**PWROG White Paper : Proposed annotation to LCO 3.4.15 Bases, "RCS Leakage Detection Instrumentation," to include Regulatory Guide 1.45 considerations**

**Recommended annotation to STS Bases for LCO 3.4.15 (note: the STS for NUREG-1432, Combustion Engineering Plants, is attached as typical):**

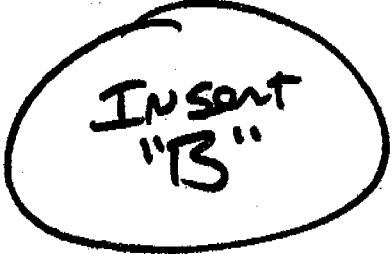
Insert  
"A"

**Insert "A":**

**RG 1.45 recommends using instruments with sensitivities of 10<sup>-9</sup> microcuries per cubic centimeter ( $\mu$ Ci/cc) for air particulate monitoring and 10<sup>-6</sup>  $\mu$ Ci/cc for the gaseous monitoring. Since the applicable monitors meet the specified sensitivity, they are designed in accordance with the guidelines of RG 1.45. However, note that with improved fuel performance and improved chemistry (i.e.: cleaner primary coolant) will have the necessary effect of extending the time required to detect a small Reactor Coolant Pressure Boundary leakage. Consequently, although the airborne particulate and gaseous radioactivity monitors may not at times be capable of detecting 1 gpm within 1 hour, they were designed in accordance with the sensitivities specified in RG 1.45.**
